PTO 03-2079

THIN FILM TRANSISTOR [HAKUMAKU TORANJISUTA]

ication/Control Number: 09/936,042

Claims 1,3-11 are rejected under 35 U.S.C. 102(b) as anticipated by or, in the alternative, under 35 U.S.C. 103(a) as obvious over Konishi '573.

Figure 1

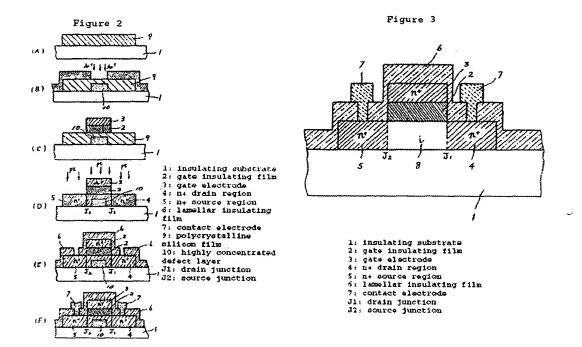
The previous rejection still applies. The new limitations do not structurally distinguish over Konishi because figure 1 of Konishi shows the recombination centers being separated from the drain region by a distance Lo which appears to be somewhere between 1/3 to 1/10 of the channel length. New claim 11 is rejected because the recited thickness is typical for a short channel thin film device as Konishi and the recombination centers in Konishi do not span the entire channel length. If applicant's can prove that the distance Lo in Konishi is not within the claimed range, claims 1-11 will be allowed.

Applicant's arguments filed 1/7/02 have been fully considered but they are not persuasive. Applicant's state that Konishi does not teach recombination centers at the claimed distance. However, as stated above, the figures of Konishi show the recombination centers to be located at the proper distance from the drain, as claimed. The Konishi article is being translated by the Patent Office.

Claims 1-10 are anticipated or obvious over '573. Note in regard to claim 8 that the recombination region 10 is also located near the side of the gate electrode.
